Access Compliance Report

Public Rights-of-Way

(Curb Ramps)

Intersection ID: 54218	Main Street: GOLF_LINKS_DR	Cross Street: SANDY_ROCK_PL	Location: SE
ADA ID: C6037268D350	Ramp Type: Perp	Initial Pass/Fail: Fail	Overall Compliance: No
Severity Score: 12.5			
Codes/Mitigation Info/Possible Solution		Field Measurements/Component Compliance

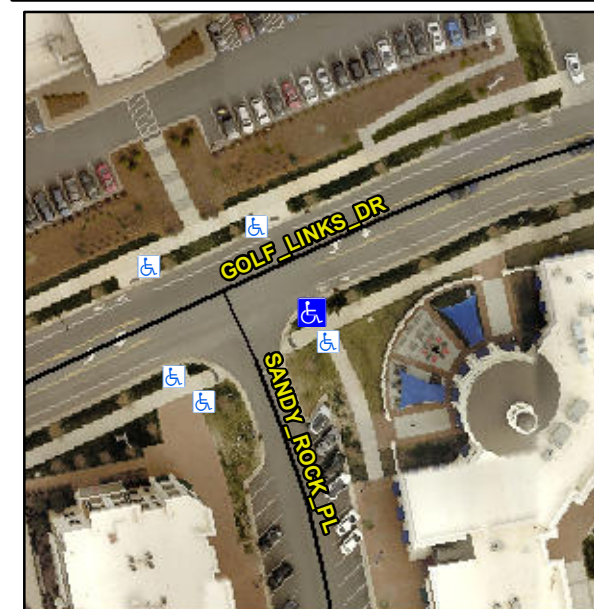
Not Found, R304.2.2

Compliance	Description	Data	Compliance	Description	Data
N/A	Ramp Length (in)	95.5	No	Ramp Slope (%)	8.9
Yes	Ramp Width (in)	94.0	Yes	Ramp XSlope (%)	0.3
N/A	Flare Type LT	N/A	N/A	Flare Type RT	N/A
N/A	Flare Slope LT (%)	N/A	N/A	Flare Slope RT (%)	N/A
N/A	Flare Traversable LT?	N/A	N/A	Flare Traversable RT?	N/A
N/A	Landing Length (in)	N/A	N/A	DWS Provided?	N/A
N/A	Landing Width (in)	N/A	N/A	DWS Contrast?	N/A
N/A	Landing Slope (%)	N/A	N/A	DWS Length (in)	N/A
N/A	Landing X Slope (%)	N/A	N/A	DWS Full Width?	N/A
N/A	Landing Curb? (Y/N)	N/A	N/A	DWS Offset (in)	N/A
N/A	Shared Landing?	N/A			
N/A	Gutter Ponding?	N/A	N/A	Gutter Slope (%)	N/A
N/A	Gutter Lip Ht (in)	N/A	N/A	Gutter X Slope (%)	N/A
N/A	Painted X Walk1?	No	N/A	Painted X Walk2?	N/A
	X Walk 1 Direction	To N		X Walk 2 Direction	N/A
N/A	X Walk 1 Width (in)	N/A	N/A	X Walk 2 Width (in)	N/A
	X Walk 1 Slope (%)	2.9		X Walk 2 Slope (%)	N/A
	X Walk 1 X Slope (%)	0.6		X Walk 2 X Slope (%)	N/A

Remove & Replace Entire Ramp.
